Minutes of the Advisory Design Panel Meeting

December 13, 2023, 2:00 p.m. Video Conference

5.3 Rezoning Application for 19261-19293 Hammond Rd

Proposed Development at 19261, 19267, 19275, 19285, 19293 Hammond Road

BUILDING 1&2 FROM HAMMOND RD

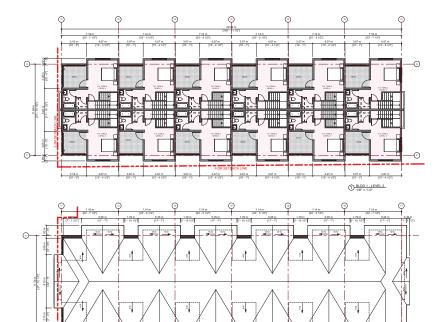
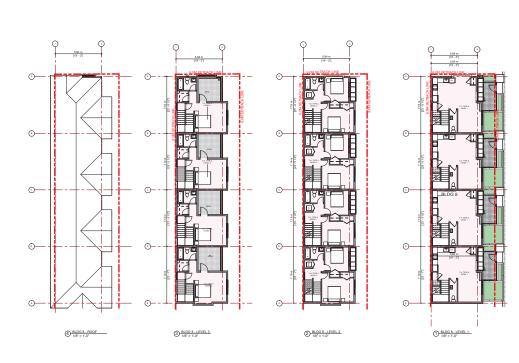
- a question was raised regarding the eight foot wide pathway and set back on Hammond Road following building one, and what led to the set back (Applicant 1 said the pathway was to connect to the cul-de-sac, and the set back was to provide privacy by increasing the landscaping);

- a comment was made about the set back and pathway on Hammond Road being favoured over the depth of the development townhouse units and that there may be an opportunity to increase the internal size of the units located beside the set back and pathway;

- City Staff asked the Panel if they had any comments about the visual repetition proposed for the development along Harris Road (A Panel Member suggested that the horizontal lines be broken down by adding some variation in terms of colors and roof height; Z. Billimoria said they had tried to define each unit; but they could break the look with a variety of finishing materials or colors);
